Service Engineering Operations
Customer Service Division

December 18, 2025

SUBJECT: **Customer Satisfaction Program 25M04**
Certain 2021-2023 Model Year F-150 HEV Vehicles
Replacement of Exhaust Gas Heat Exchanger Coolant Spigot, If Required

FIGURE 1

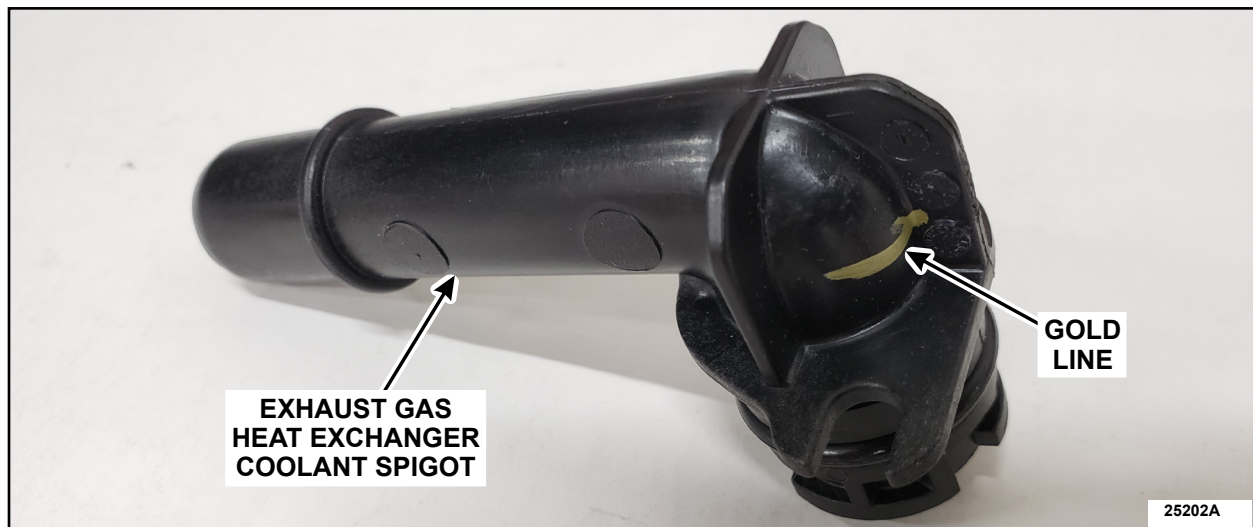
1. Remove both of the exhaust gas heat exchanger coolant spigots. Follow the Workshop Manual (WSM) procedures in Section 309-00D.
2. Visually inspect the *new* exhaust gas heat exchanger coolant spigots for a gold line marking. The gold line marking indicates the correct part(s) for installation. If the spigots do not have the gold line marking, do not use these parts and order new spigots. See Figure 1.

3. Install both of the *new* exhaust gas heat exchanger coolant spigots that have a gold line. Follow the WSM procedures in Section 309-00D.
